## HATZ ENGINE EGR DTC CORRECTIVE ACTION

### SPN 2791 FMI xxx

**Production Change Begins with Machine Serial Number: NG2003610**

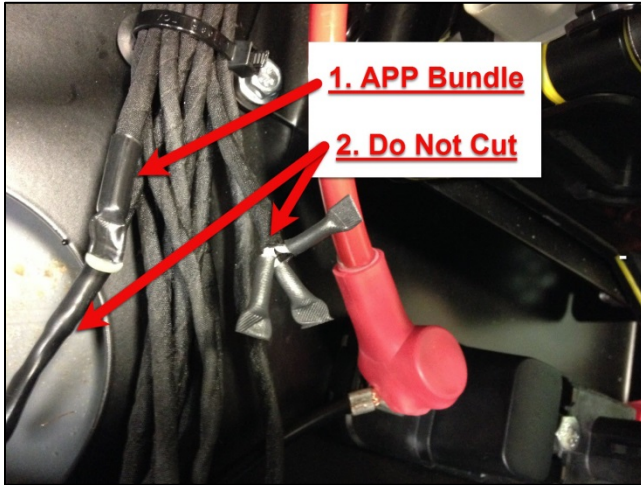
1. Locate APP wire bundle in the Hatz engine harness coming off the X1 connector. The APP wire bundle should be terminated 12 to 14 inches from the X1 connector.

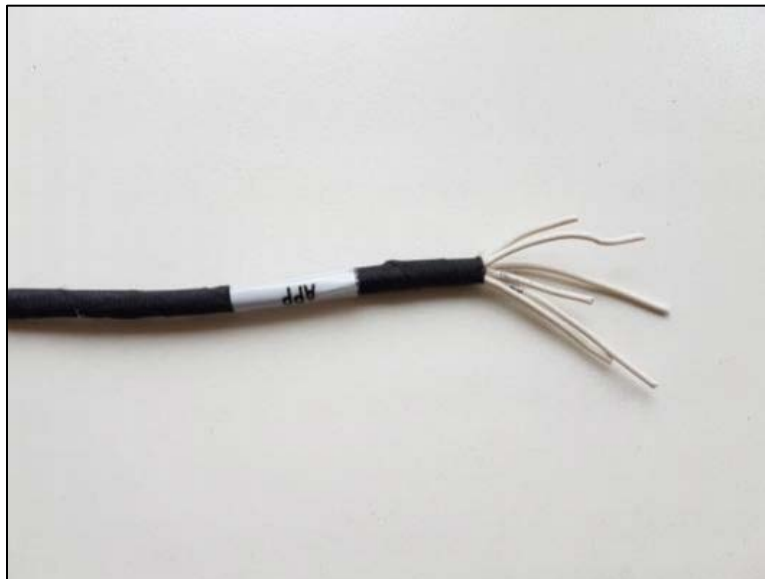
2. Once located, remove the factory shrink tube and expose the (6) flush cut wires. Smaller diameter 3 wire bundles should be left as is.

3. Remove 2 inches of the original Hatz fabric tape. Cut wires in the APP bundle to varying lengths, minimum of ¼ inch apart.

4. Use a self-adhesive shrink tube for each wire and crimp the shrink tube on the end of the wires.

5. Cover all 6 wires with a large self-adhesive shrink tube.
